TUBELITE[®]
STOREFRONT, CURTAINWALL & ENTRANCES
DEPENDABLE

Engineering Bulletin: **090903**

Subject: **Horizontal SSG Clips**

E4TB246

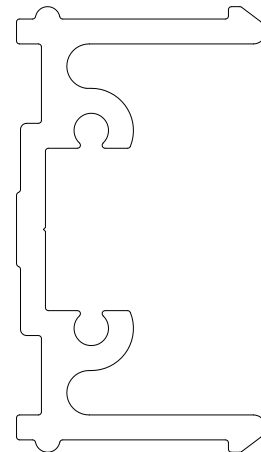
Description: New frame clips have been developed for the 400 series curtain wall horizontal SSG mullions. These new clip are made from extrusion E4TB246 and will align with the SSG reglet and provide easier drilling for concealed screw attachment.
